TECHNICAL EVALUATION REPORT

EVALUATION OF SPENT FUEL RACKS STRUCTURAL ANALYSIS

OYSTER CREEK NUCLEAR GENERATING STATION
GPU NUCLEAR

NRC DOCKET NO. 50-219

Figure 1. Dynamic Model

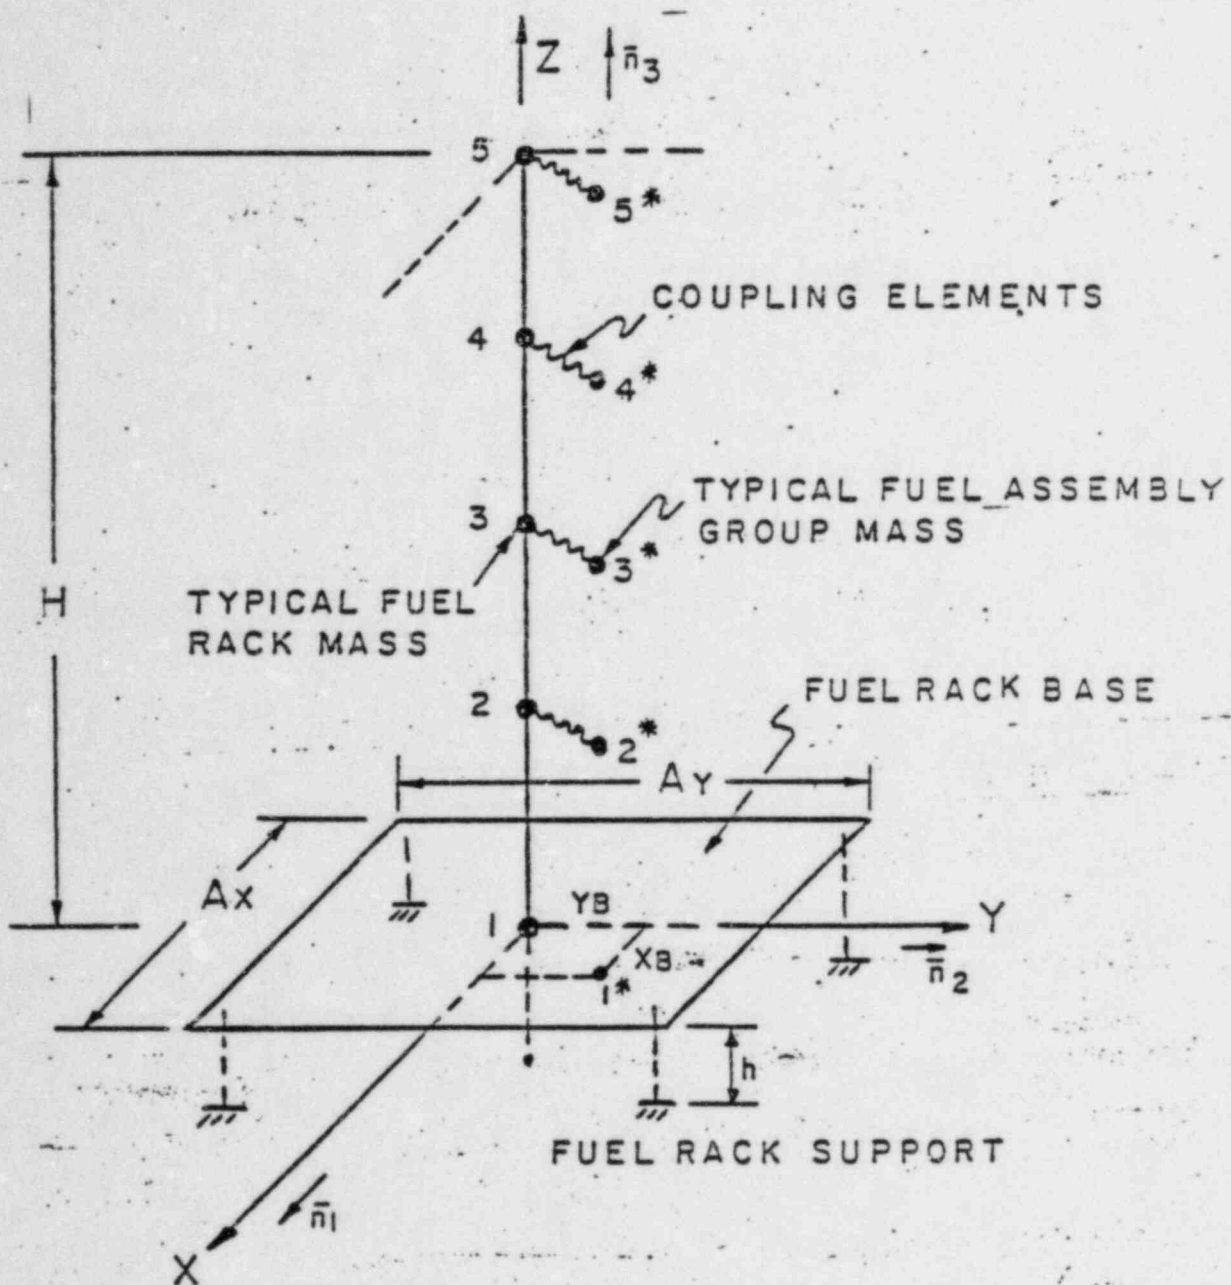
The lumped mass approach was used in the dynamic model, wherein the mass of the fuel rack was lumped at five equidistant locations as shown in Figure 1. For horizontal motion, the rack mass was proportioned at one-quarter of the total mass for each of the three middle mass nodes and at one-eighth of total mass each for the top and the bottom nodes. The mass of the base plate and support structure was lumped with the bottom node. For the fuel assemblies, five lumped masses were used in a similar pattern of distribution. For vertical motion, two-thirds of the racks' dead weight acted at the bottom mass node, with the remaining one-third applied at the top node. All of the dead weight (gravitational force) of the fuel assembly was at the bottom node.

The Licensee included 32 degrees of freedom in the lumped mass model. All rack mass nodes were free to translate and rotate about two orthogonal horizontal axes. The top and bottom rack mass nodes had additional freedom for translation and rotation with respect to the vertical axis. The bottom fuel assembly mass node was assumed fixed to the base plate, whereas the

Figure 2. Module Layout

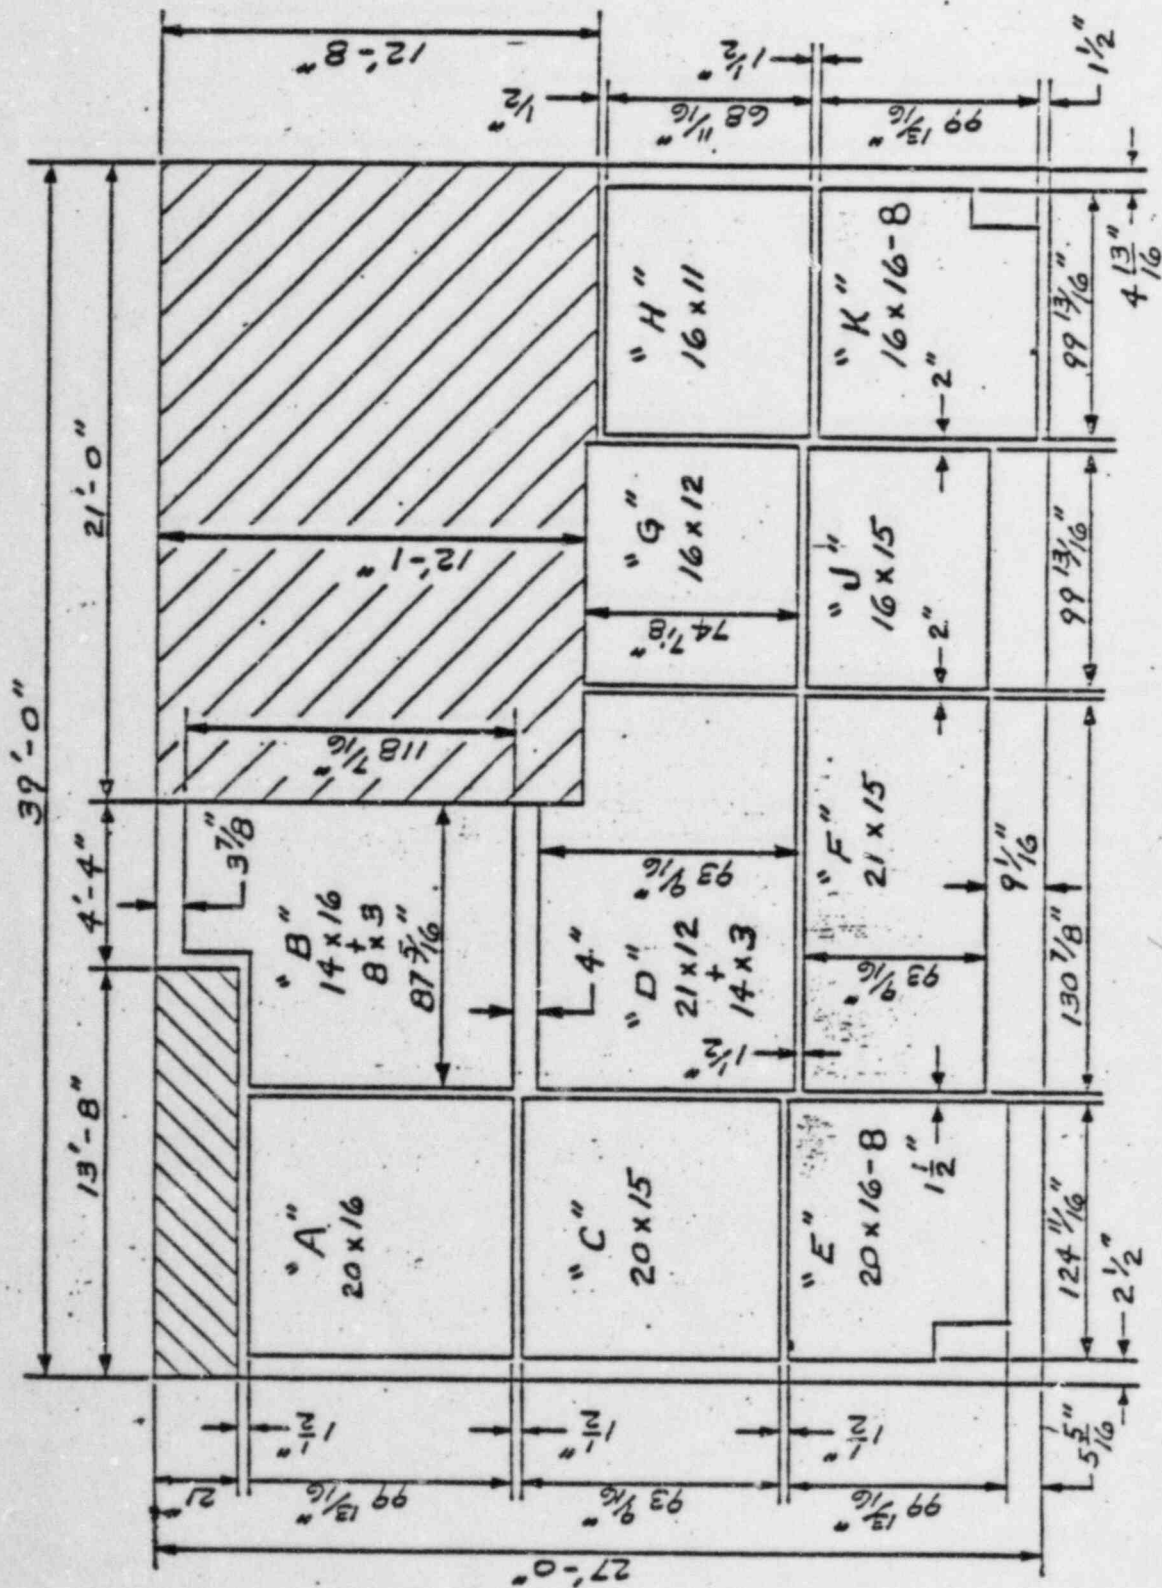
used to simplify the inter-rack interaction problem to a standard configuration [8]. This equivalent gap will form a bounding space around the rack, which fluid is assumed not to cross.

It was noted that rack module F had a maximum computed displacement of 1.298 in, whereas the installed clearance with the adjacent module was 1.5 in as shown by the Licensee's Figure 2.1 [1]. Thus, 1.298 in was greater than half the 1.5-in gap (0.75 in), but the combined displacement of E and F was less than the total clearance.
